PLAN AND ZONING COMMISSION

REPORT TO PLAN AND ZONING COMMISSION Meeting Date – October 4, 2016

REQUESTED ACTION: A conditional use to permit establishment of a 12,660 SF “shopping center” in the Commercial Core area of Mahomet on a ~32,600 SF parcel. The development as proposed is a conditional use in the C-2 General Commercial Zoning District.

OVERALL SITE PLAN
NEW RETAIL BUILDING
602 E. MAIN ST.
MAHOMET, ILLINOIS

Example 3

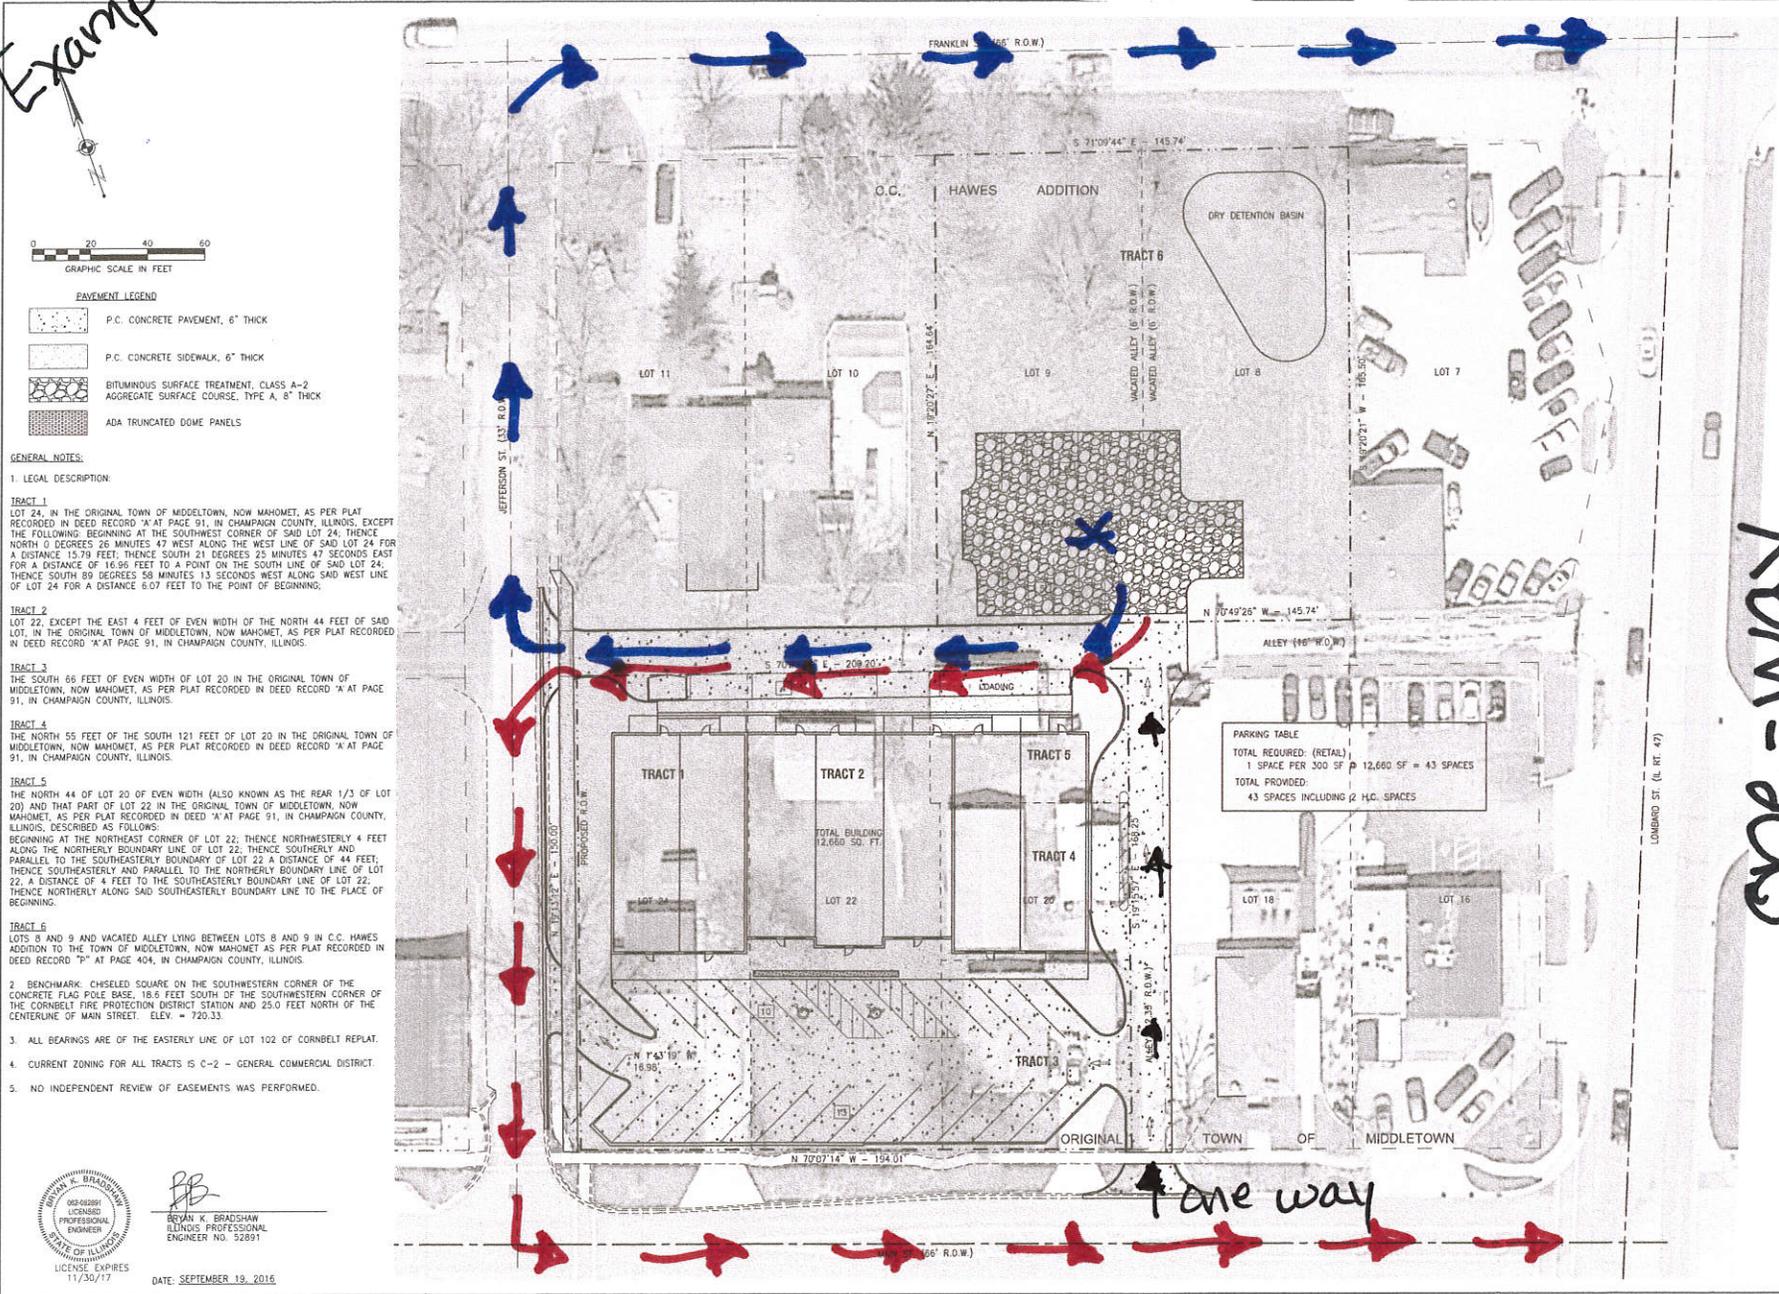
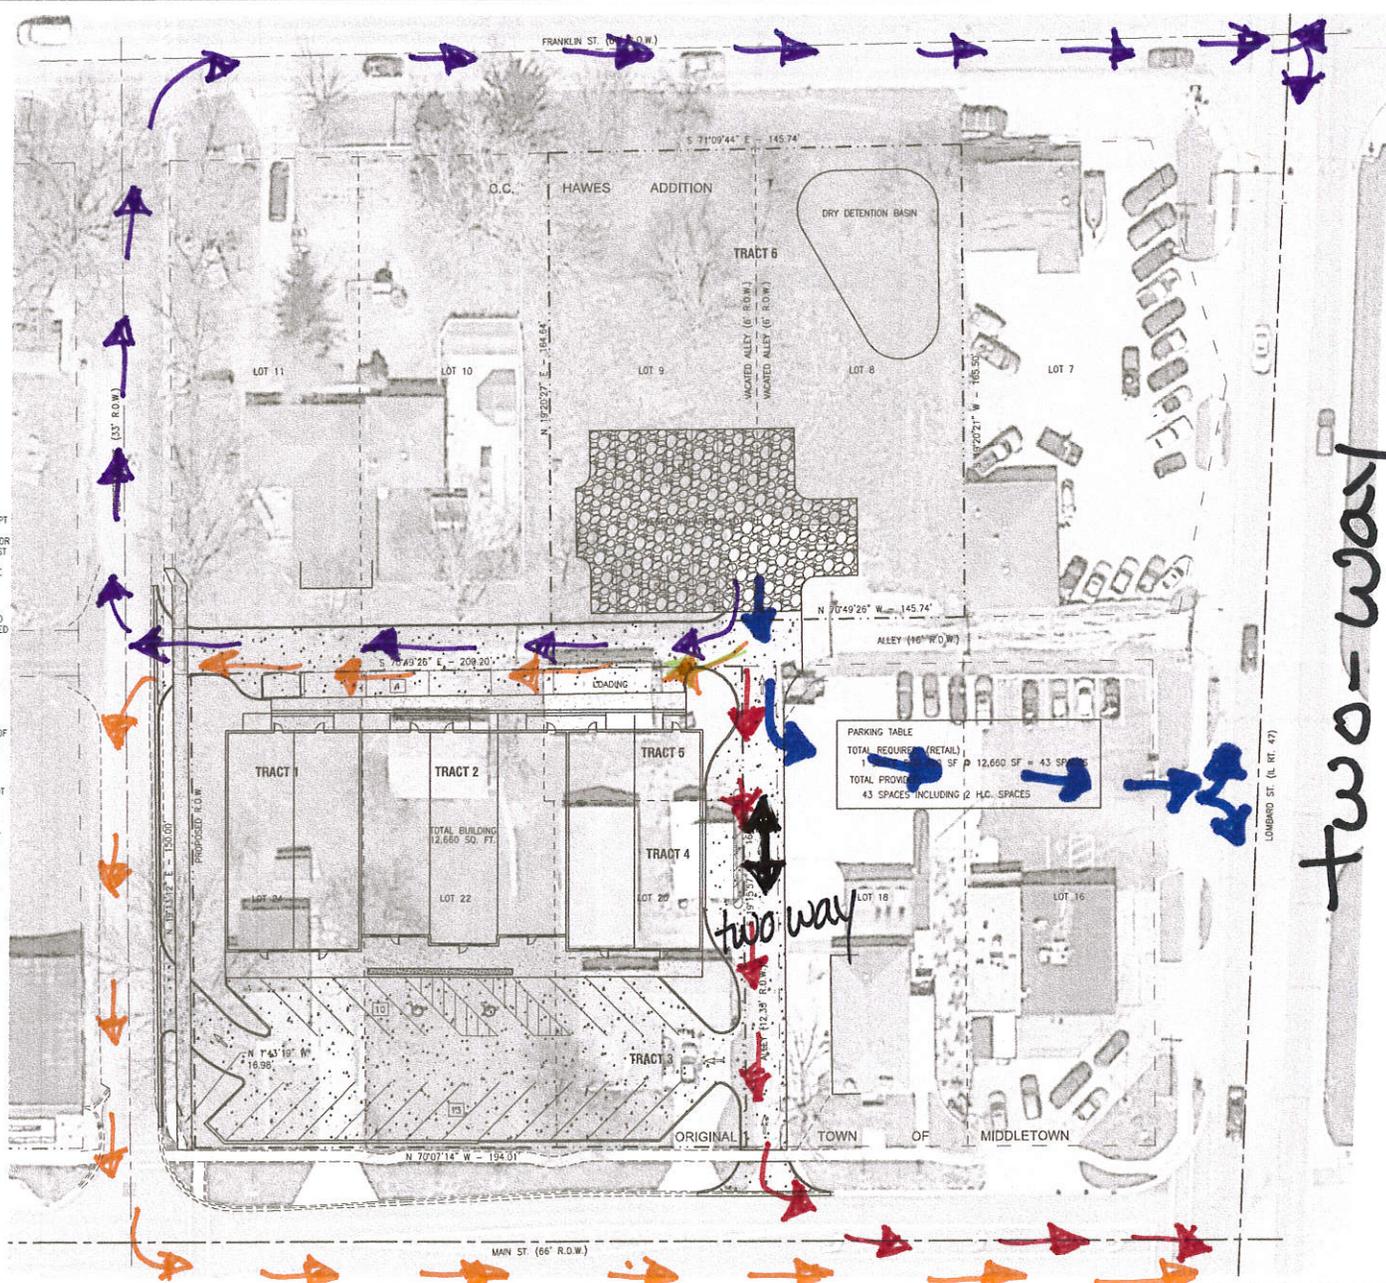
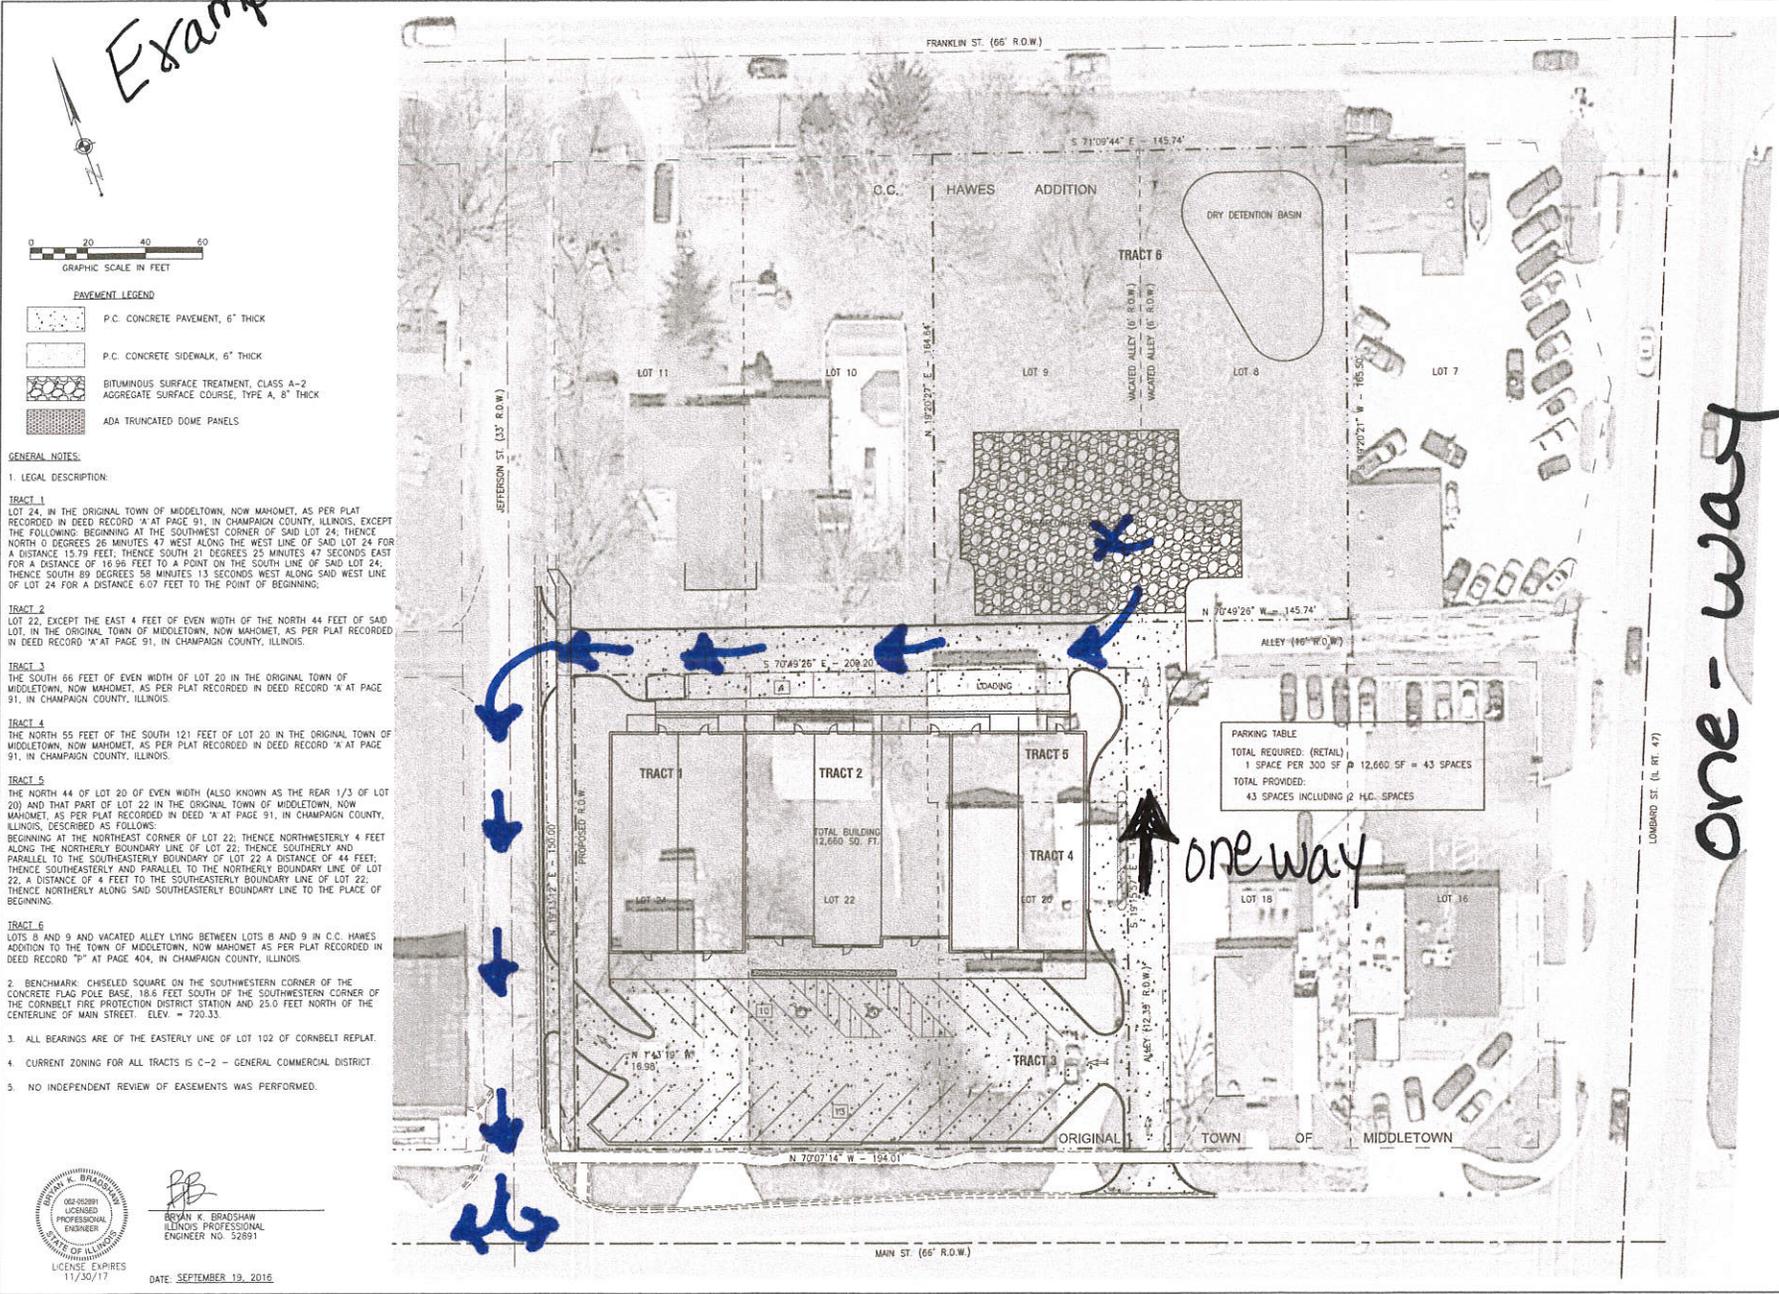
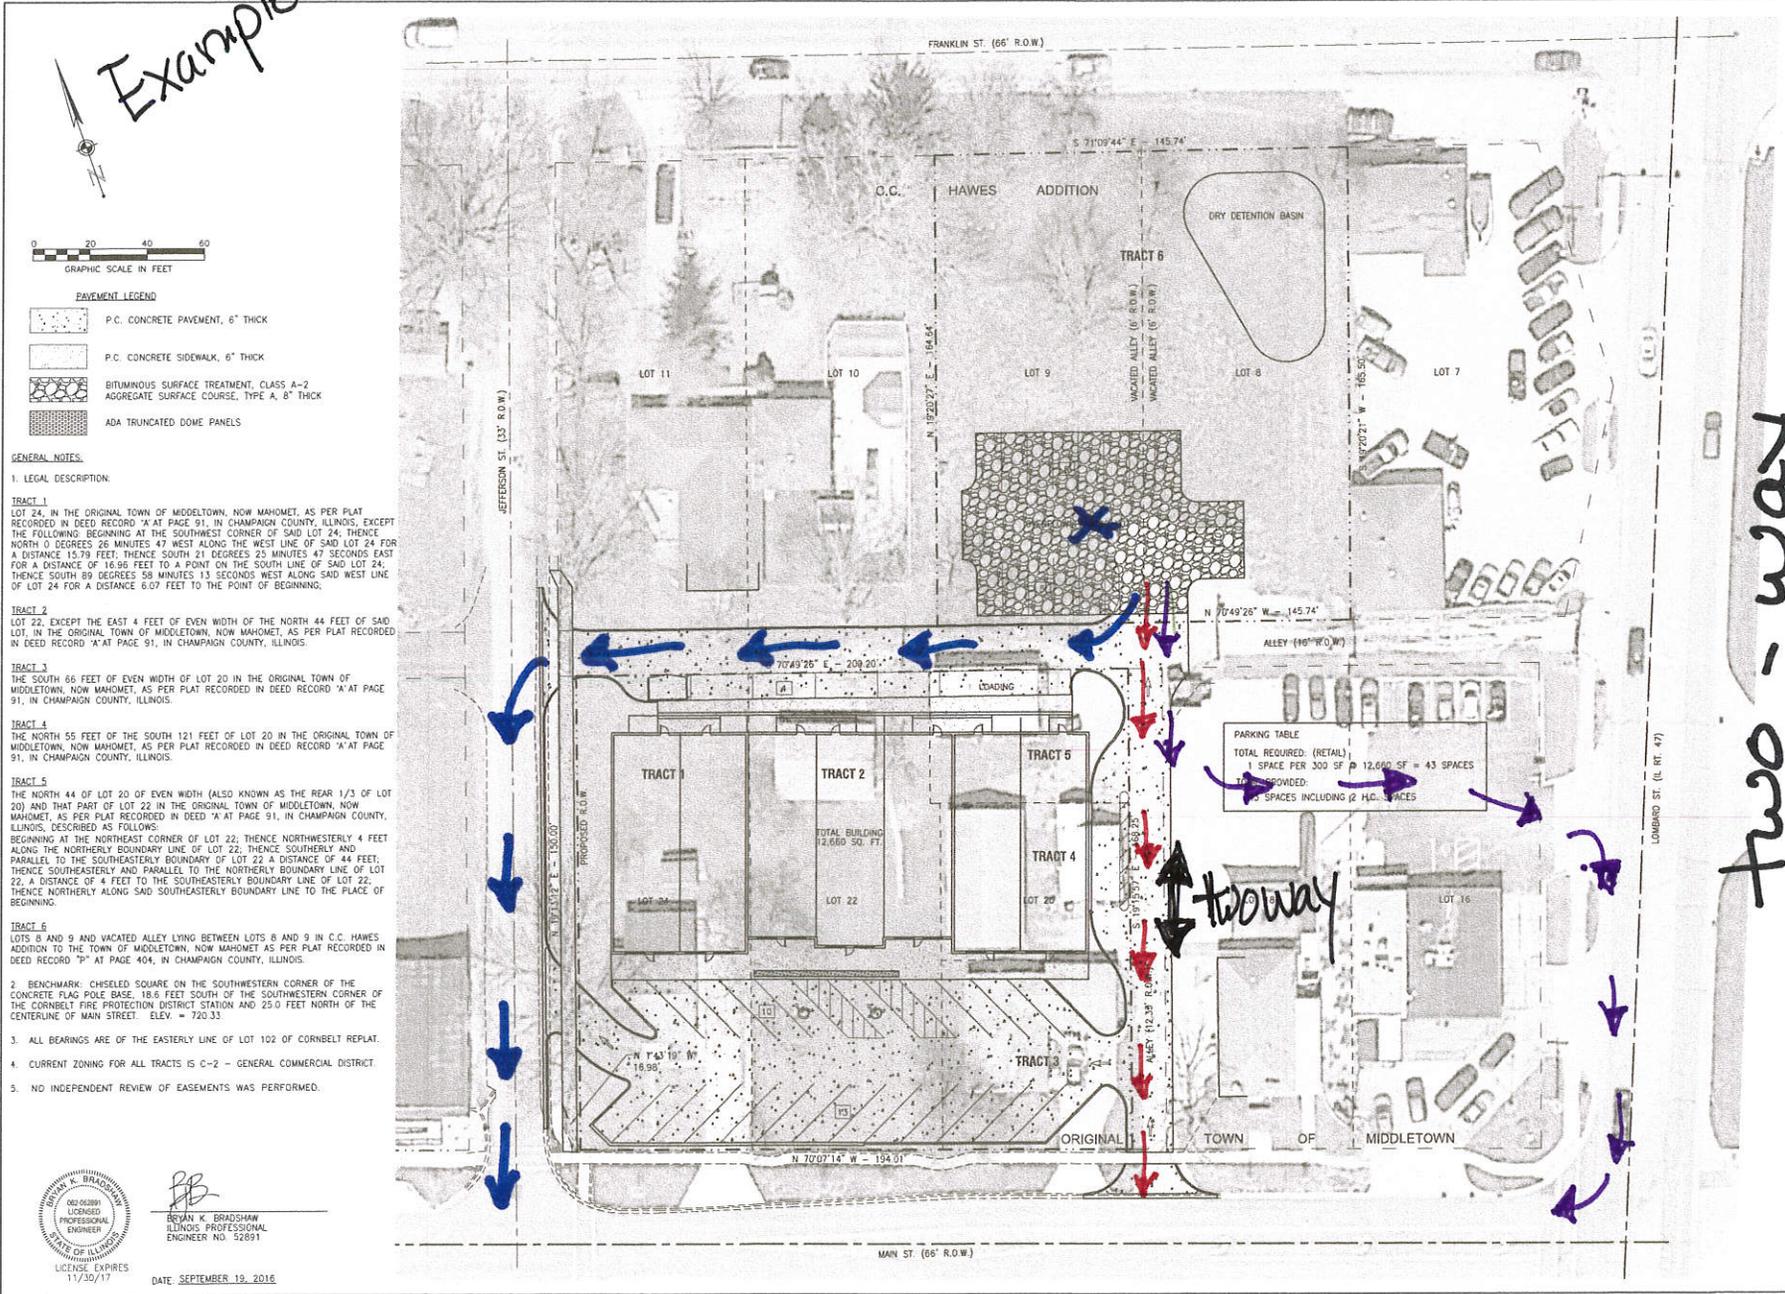
See attachments for examples and options related to vehicles entering and those exiting from various areas to various destinations. The exhibits show the effect of the proposed one-way and indicate the effect if the alley on the east side of the property was two-way.

So off-site parking lot vehicles will exit the site onto Jefferson and proceed left to get to Main Street. This is a challenging intersection. If the destination is Lombard, the vehicle has to turn right onto Jefferson and right again onto Franklin to get to Lombard. Fortunately the Lombard / Franklin intersection includes a traffic signal. If the alley were two-way, a vehicle could exit the site via the Wingery lot to Lombard or travel directly south on the alley to Main Street. Three (3) possible exits are added for the off-site lot if the alley is two way.

7. **Wingery and Taffie's lot exiting change.** Traffic from these sites would no longer have the ability to exit onto Main St.. The vehicles would have to exit directly onto Lombard or get to Main St. by traveling west along the alley to Jefferson St. This is a very out of the way method of exit and likely most people won't prefer this option. Nor do staff see a method of pavement marking and areas for signage that could assure vehicles do not turn left when reaching the north / south alley and traveling south as they have been able to do for years.
